Docket Item #14  
BAR CASE# 2005-00172

BAR Meeting  
July 27, 2005

**ISSUE:** Addition and alterations

**LOCATION:** 1210 Queen Street

**Figure 1** North elevation

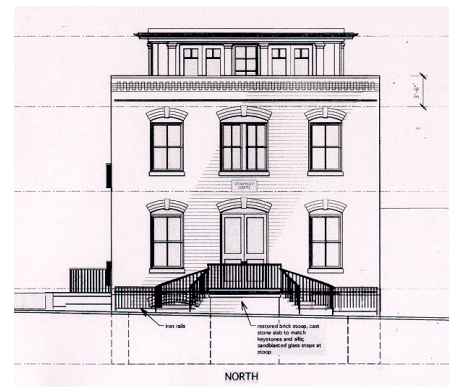
Front (north) Elevation - The existing front entrance will not be functional but will be retained. It will have half glazed wood doors. The existing non-original stairway will be replaced by a new double sided stairway. In plan, each stair will curve out toward the street. The landing will be cast stone to match the existing cast stone on the building. The treads will also be of cast stone (a change from the sandblasted glass shown on the plans). The risers will be open to allow light into the wells below. The front face of the stoop will be of blond brick to match the existing building while the vault on the underside of the stoop will be red brick. There will be metal railings on either side of the stairs, the front of the landing, and surrounding the window wells at the front of the building. The railings will be simple iron picket railings with a black finish. In the basement level, the opening to the right of the front door, which is currently bricked in, will be re-opened to serve as a window. The existing basement level door to the left of the front door will be closed down to become a window. The existing cast stone plaque above the door will be inscribed with “Cromley Lofts.”

- 1) That the windows and glazed doors in the existing building be replaced with true-divided light windows rather than simulated divided light windows;
- 2) That the existing building be repointed in conformance with the guidance provided in the National Park Service publication, *Preservation Brief #2: Repointing Mortar Joints in Historic Brick Buildings*;
- 3) That there be no thru-wall air conditioning units;
- 4) That the HVAC units be located on the west side of the third story roof deck;
- 5) That the west wall of the addition and rear egress stairway be clad in metal shingles; and,
- 6) That the front steps have cast stone rather than sandblasted glass treads.

**Figure 2** East elevation

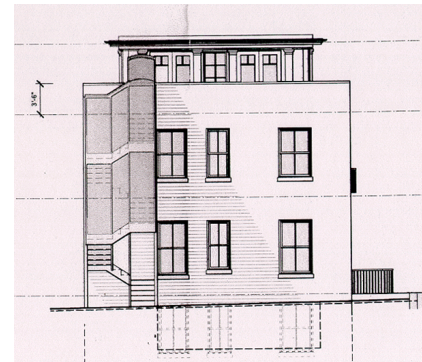
East (side) Elevation - Two existing windows on the east side at the center of the facade will be lengthened to become doors and will be accessed by a single stoop with a gently curved front. The doors will be fully glazed and will have a two light transom above. Cast iron globe light fixtures

(“Portland” model W450 by Rejuvenation Lighting) will be located on either side of the entry. The stoop will have metal railings matching those at the front and will be connected to the access

ramp/raised walkway that extends along the east side of the property. The existing basement level openings on the east elevation will be reopened and elongated to serve as windows for the basement units. Window wells will be constructed for each of these windows. The wells will be covered with grates or glass block. The four wider openings on the first and second stories of the east elevation, which appear to have originally served as freight doors, will be treated as doorways with a pair of half glazed, inward swinging doors. Outside each door will be a gently curved metal railing.

**Figure 4** West elevation

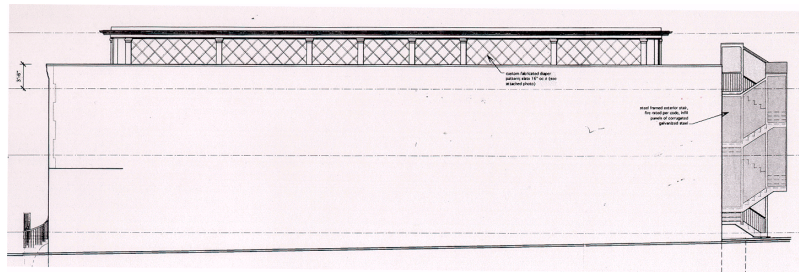
The west elevation will have no openings. Eight pilasters arrayed in the same spacing as on the east elevation will create seven panels along the wall. Rather than having a lattice pattern created by applied slats, as indicated on the drawings, the wall panels between the pilasters will be clad in metal shingles having a diamond pattern. The shingles will have an exposed surface measuring 14" by 14". They will be copper and will be allowed to develop a natural patina.
